SERVICE BULLETIN MAINTENANCE OF WAY EQUIPMENT

DATE: 5-20-2003 **BULLETIN NO:** 03-008

TITLE: SLC 503 CPU OPERATING SYSTEM UPGRADE KIT #200713

PRODUCT SERIES / MODEL: RGH8 Series A Rail Grinders

FIGURE 1
SLC 503 CPU MODULE - FRONT VIEW

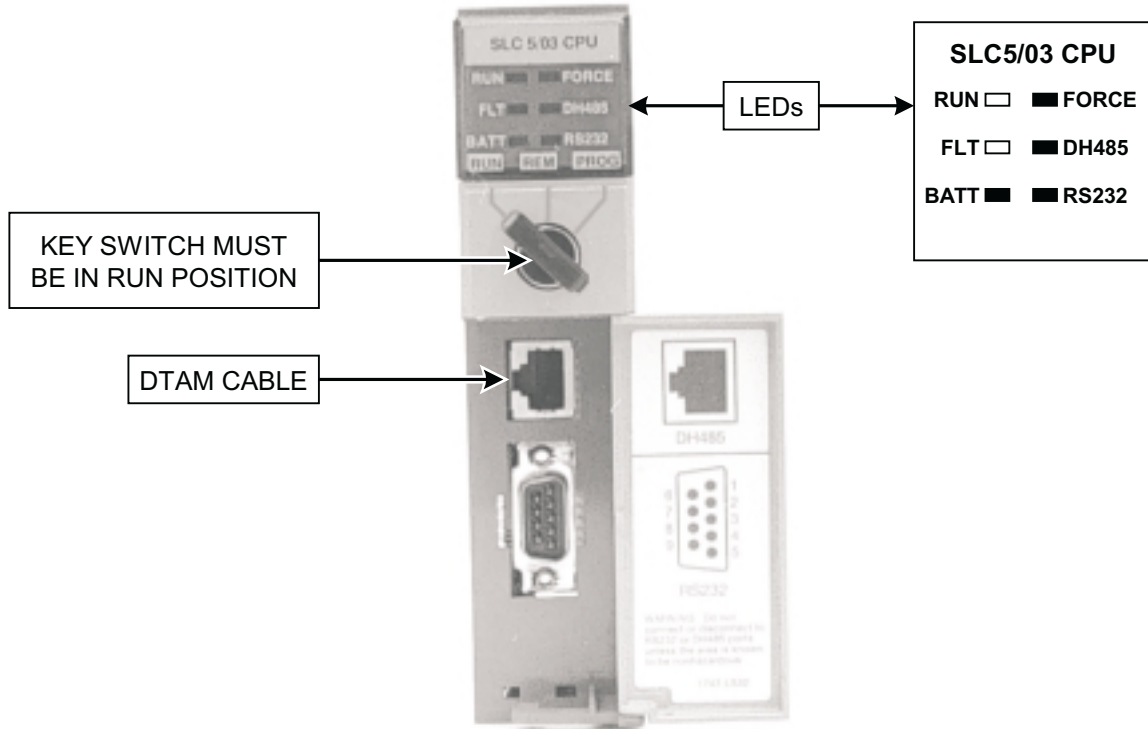
SUMMARY: Our vendor (Allen-Bradley) has obsoleted the existing M11 memory module #F026079 that is used on the SLC 503 CPU Module and replaced it with a new M13 memory module #200684. While the existing M11 module will work on all existing operating systems OS300, OS301, OS302A, OS302B and OS302C, the new M13 module requires an operating system OS302C or higher.

OPERATIONAL IMPACT: If the existing M11 module #F026079 is ordered as a repair part, it will be superceded by the new M13 module #200684. The new M13 module will work only on operating system OS302C or higher.

ACTION: Verify operating system OS302C or higher before ordering new M13 memory module to replace existing M11 memory module. If other than Operating System OS302C is currently installed, order Operating System Upgrade Kit #200713. See Identifying Instructions and Ordering Instructions in this Service Bulletin.

5. Remove existing M11 Memory Module #F026079 from socket on CPU Module.
6. **Important:** Move jumper from "PROTECT" to "PROGRAM" on CPU Module.
7. Remove Upgrade Module #FOR007526 from shipping package. Install Upgrade Module in socket on CPU Module.

12. After Operating System has been successfully upgraded in approximately 2-1/2 minutes, four LEDs (RS232 - DH485 - FORCE - BATT) on front of CPU Module will remain On steady as shown in Figure 1.
